## RELEASE NOTES

### **MGSFlood Version 4.42 – May 10, 2017**

Original Schematic

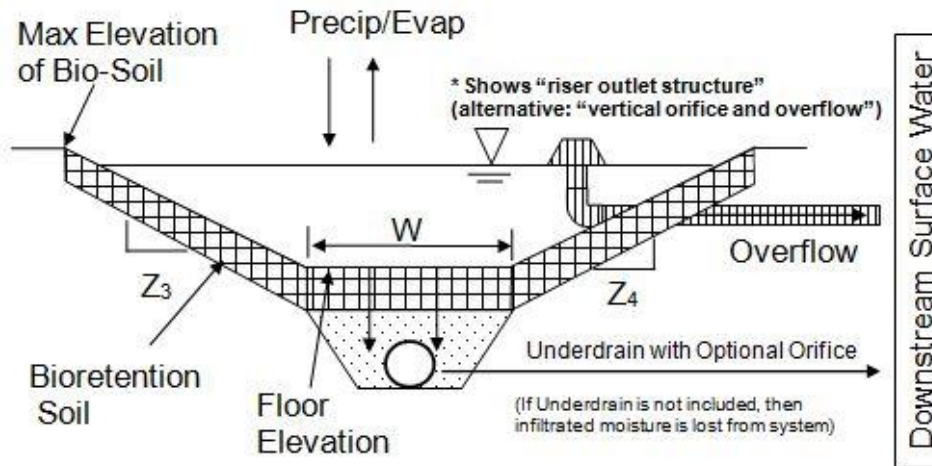
- ❖ Modified the bioretention facility routine to allow simulation of vertical side slopes, which is useful for planter simulation. New Bioretention schematic shown below.

- ❖ Changed bioretention facility so that biosoil was truncated on sides based on maximum possible water level in pond. The maximum level is determined by the elevation entered by the user.
